DIN 41612 / IEC 60603-2 Female Connectors New Design

ERNI introduces a new design of its female DIN connectors. The new design offers the following advantages:

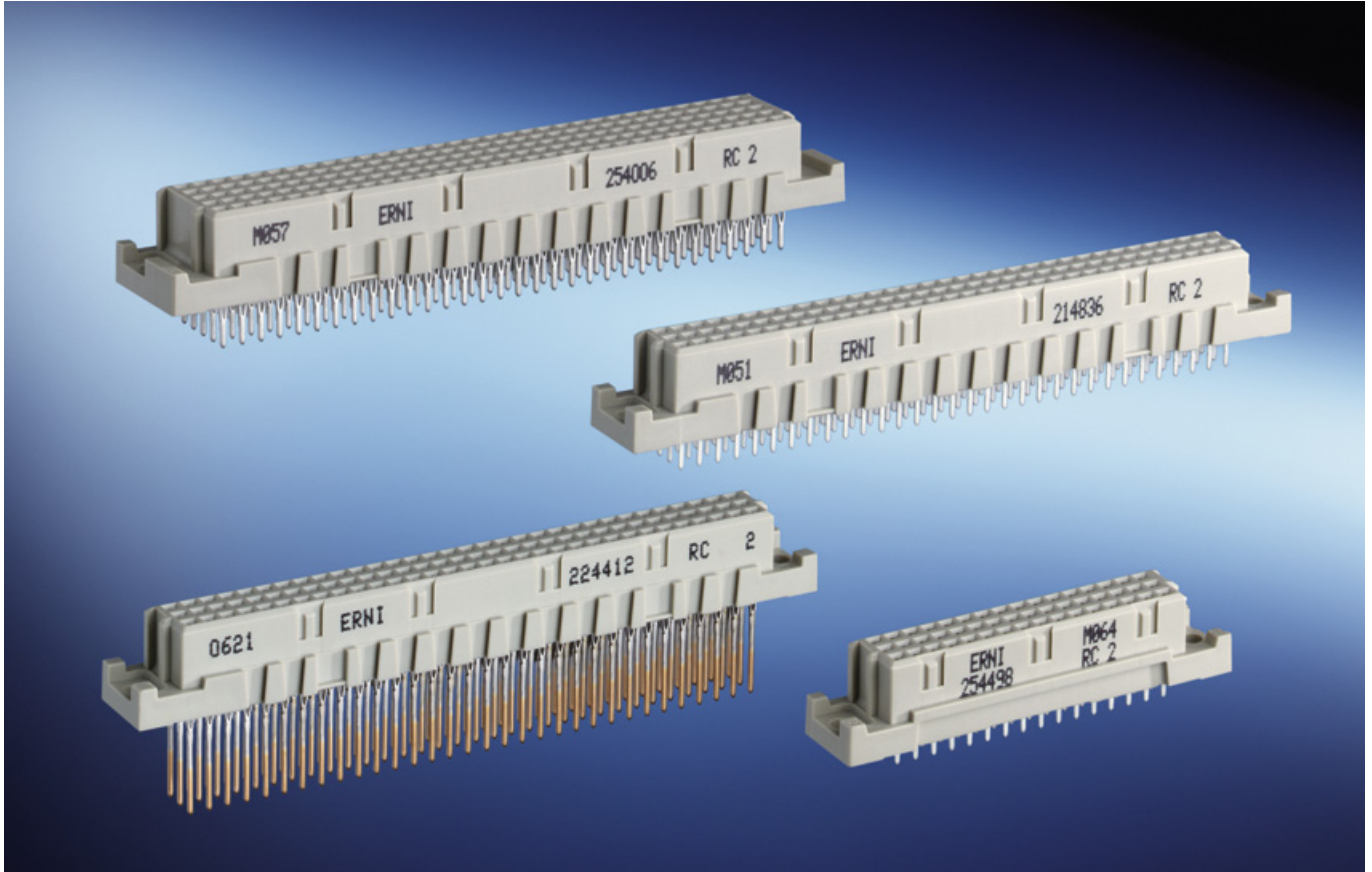
- Reduction of press-in force by approx. 25%, using the new „Eye of the Needle“ pressfit zone. This leads to lesser strain towards the PCB.
- 100% controlled quality of the pins due to consequent usage of Automated Optical Inspection during the manufacturing process.

- Partial and mixed loading possible.
Available termination lengths:
Solder: 2.5 mm; 3.7 mm; 4.0 mm; 13.0 mm; 17.0 mm
Pressfit: 2.9 mm; 4.0 mm; 5.5 mm; 13.0 mm w. Transfer Zone; 17.0 mm w. Transfer Zone
Wire Wrap: 13.0 mm; 17.0 mm

- Dimensions of insulation bodies remain unchanged for backwards compatibility.
- Fixation clip or retaining loop for efficient mounting of the connector when soldering is selectable in all positions.

- Solder stop versions, preventing a rising of the solder up into the housing, available on request for type B and C connectors.
- Transfer zone contacts are selectable for all versions.

- A simple coding mechanism, by using coding strips, is standard on all type B, C, E and CD connectors.
- The THR versions are made of a high temperature resistant material which makes them suitable for reflow soldering.
